**ADDENDUM #1
NCDOT TIP: EB-5014
LOVILLS CREEK AND ARARAT RIVER GREENWAY – MOUNT AIRY, NC**

ISSUED DECEMBER 11, 2014

LOVILLS CREEK AND
ARARAT RIVER GREENWAY
WORTH STREET TO THARINGTON PARK

TYPICAL SECTION AND GENERAL NOTES FOR BRIDGES

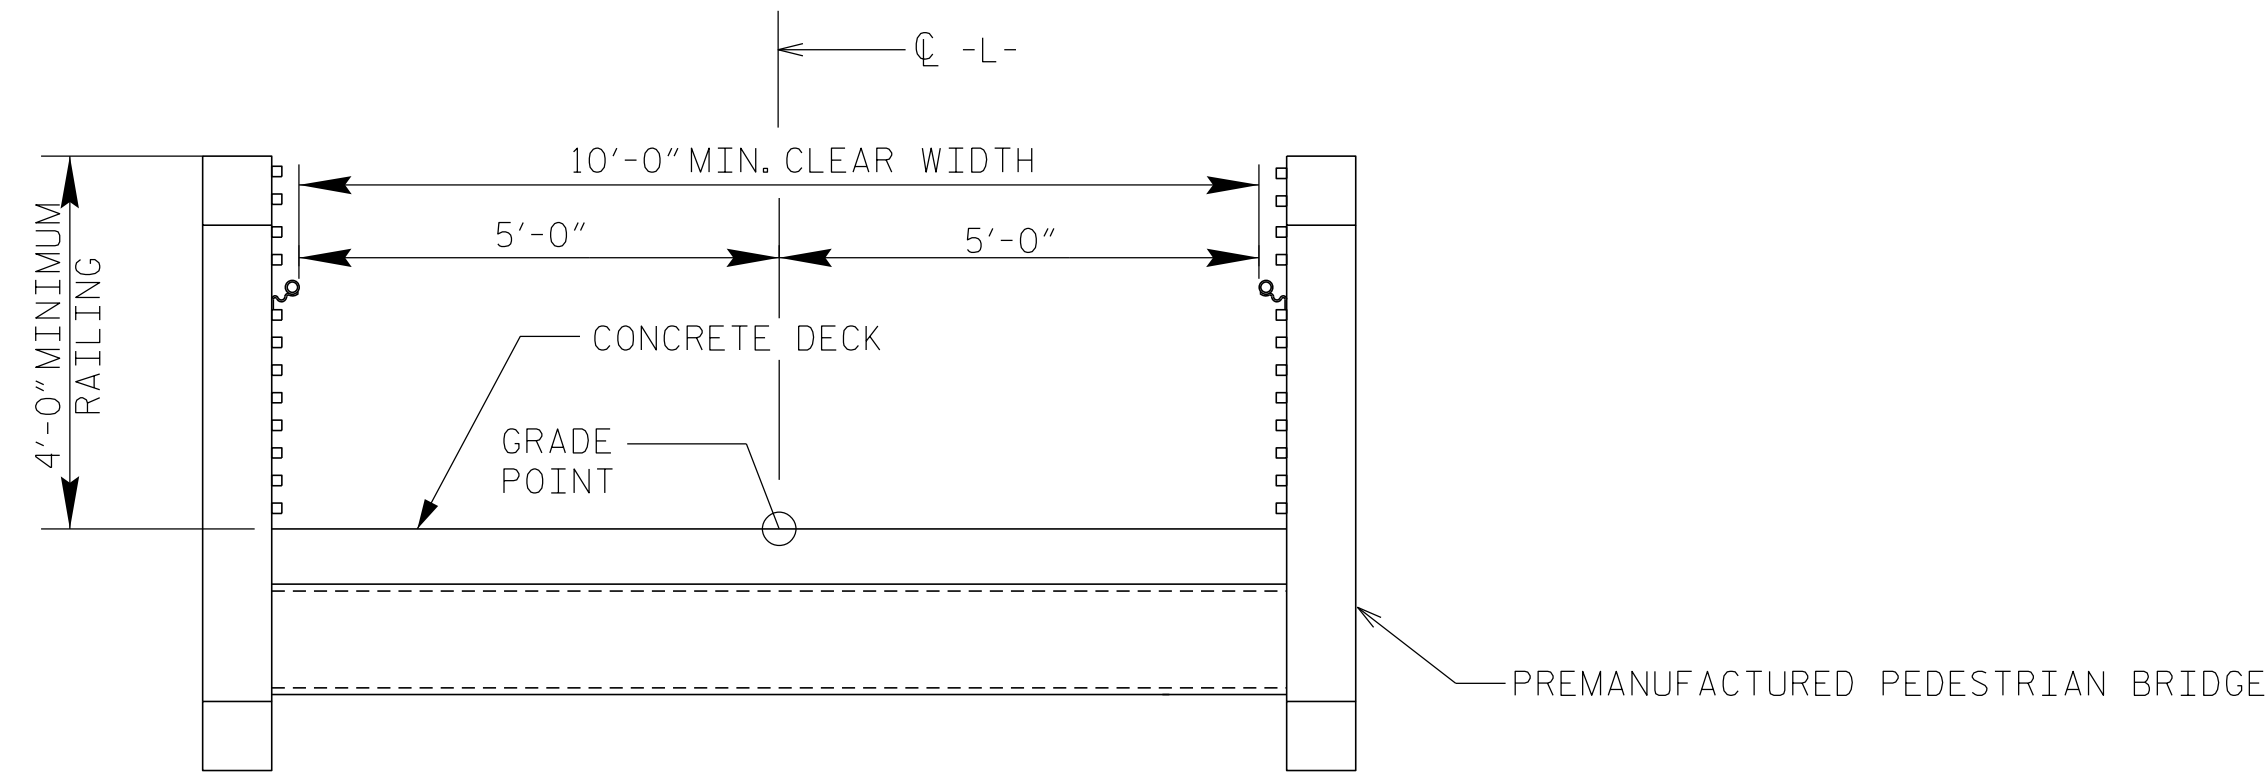
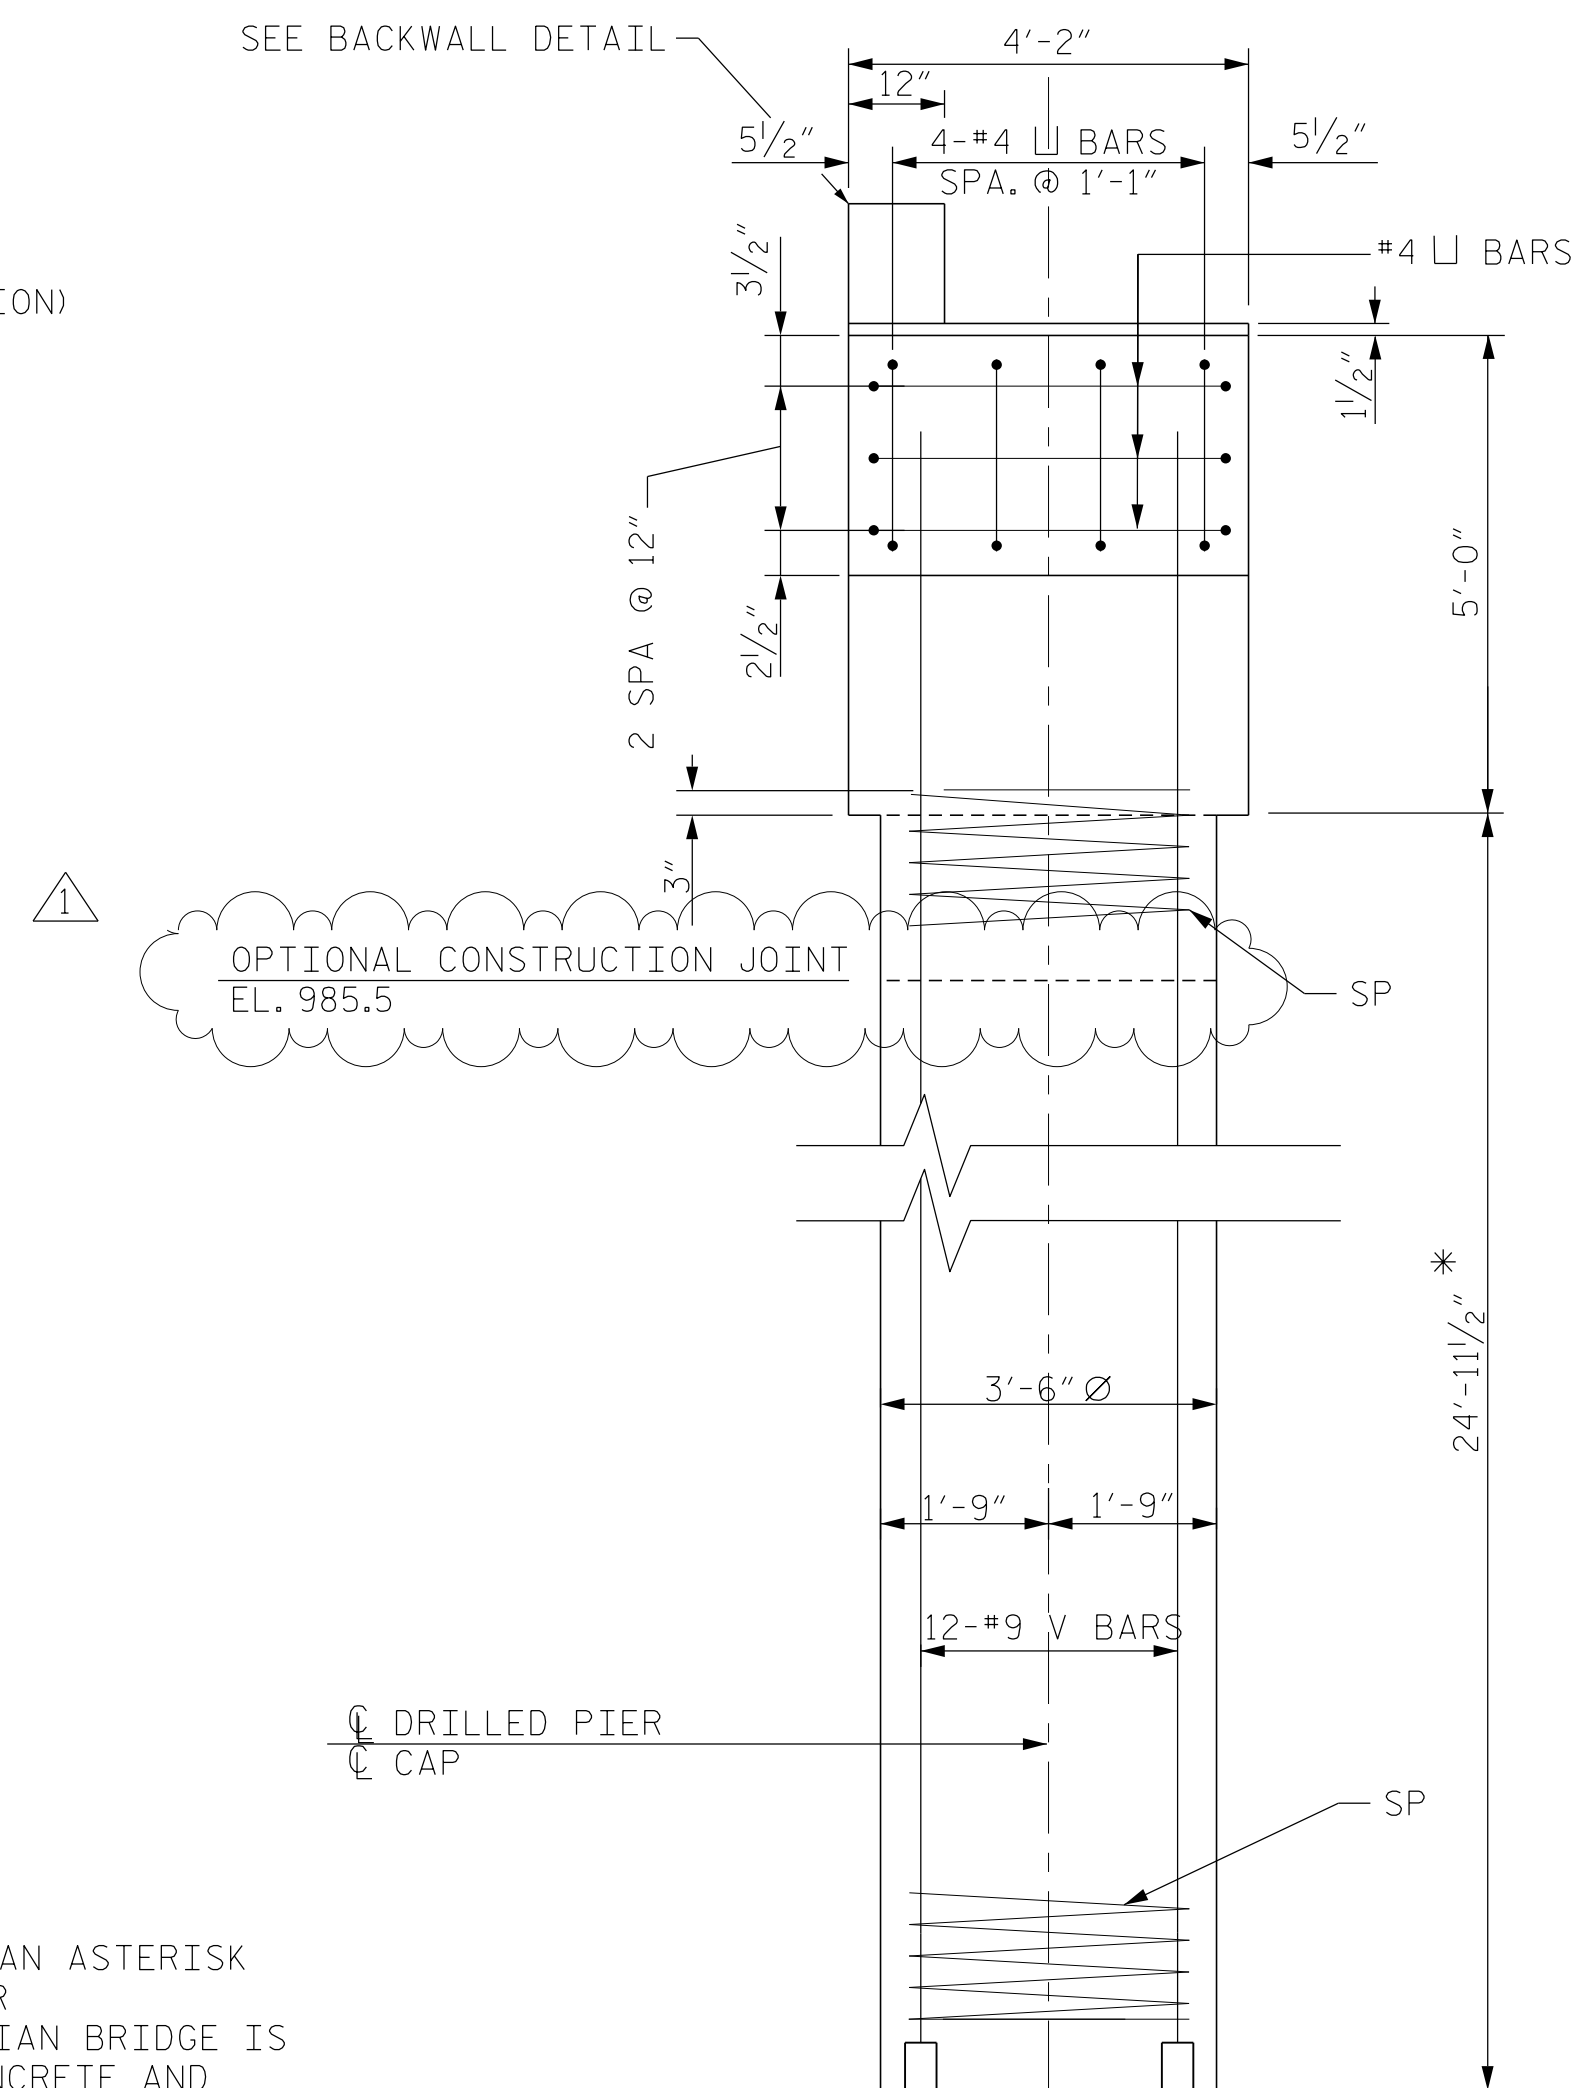
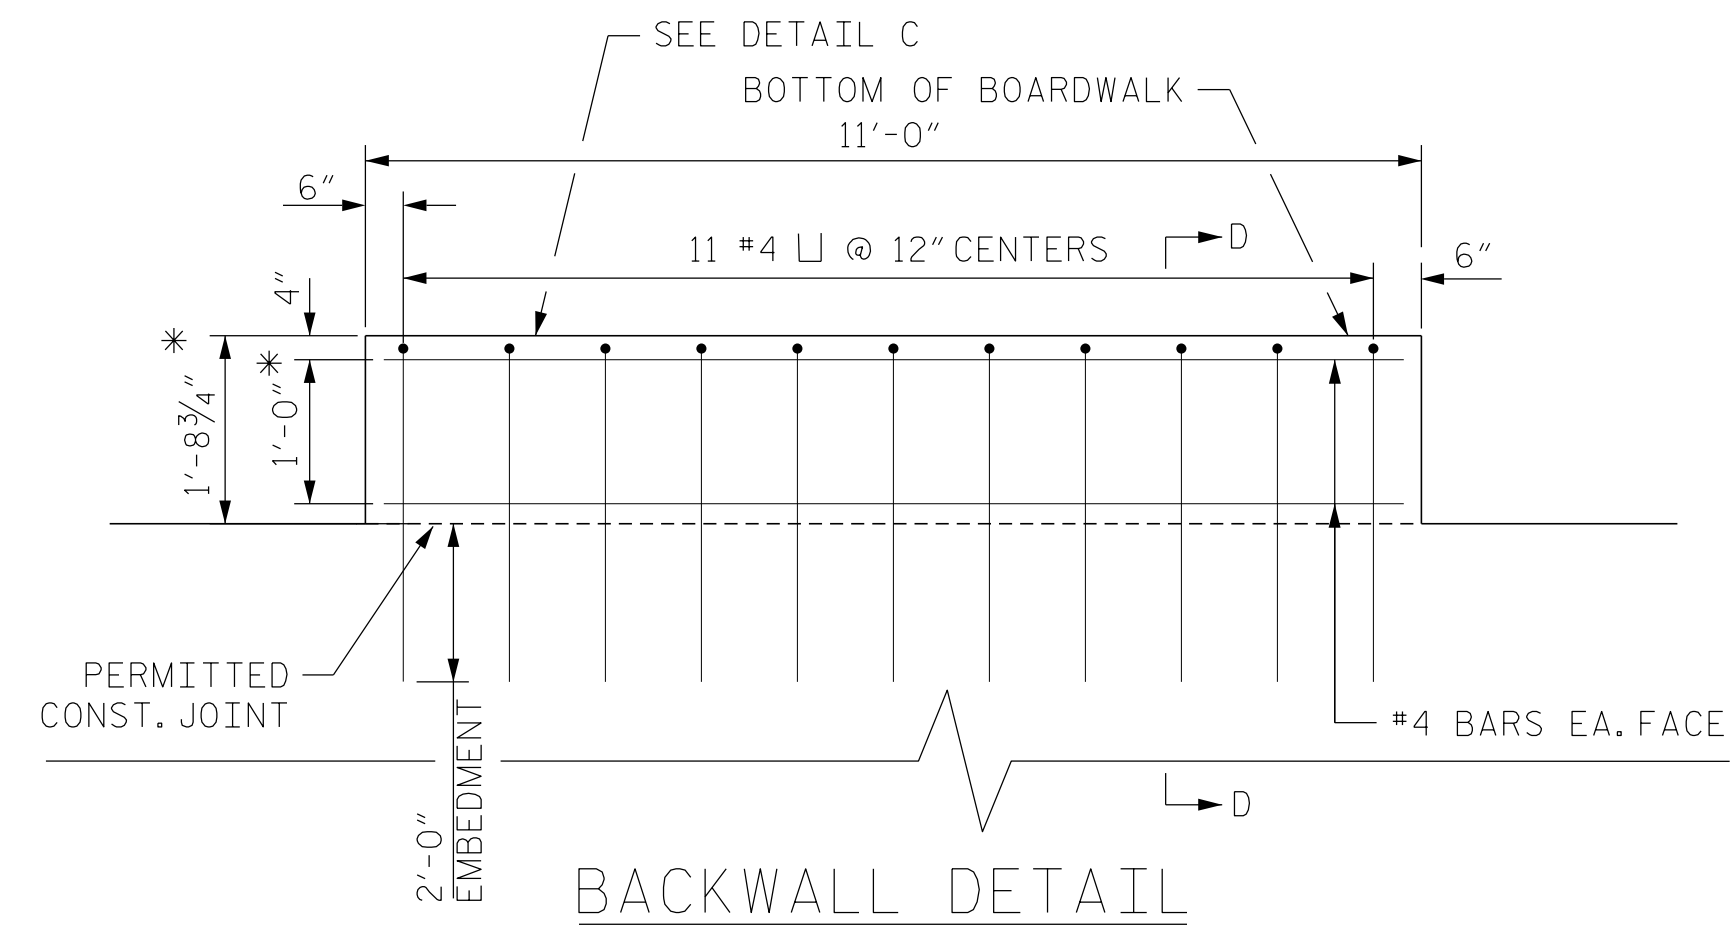
- Typical section limits on sheet 2 have been clarified.
- Plan sheets S1, S3, S4, S5, S6, and SB-1 have been modified to reflect final NCDOT review comments.

12/10/2014 REVISED/ADDED NOTES
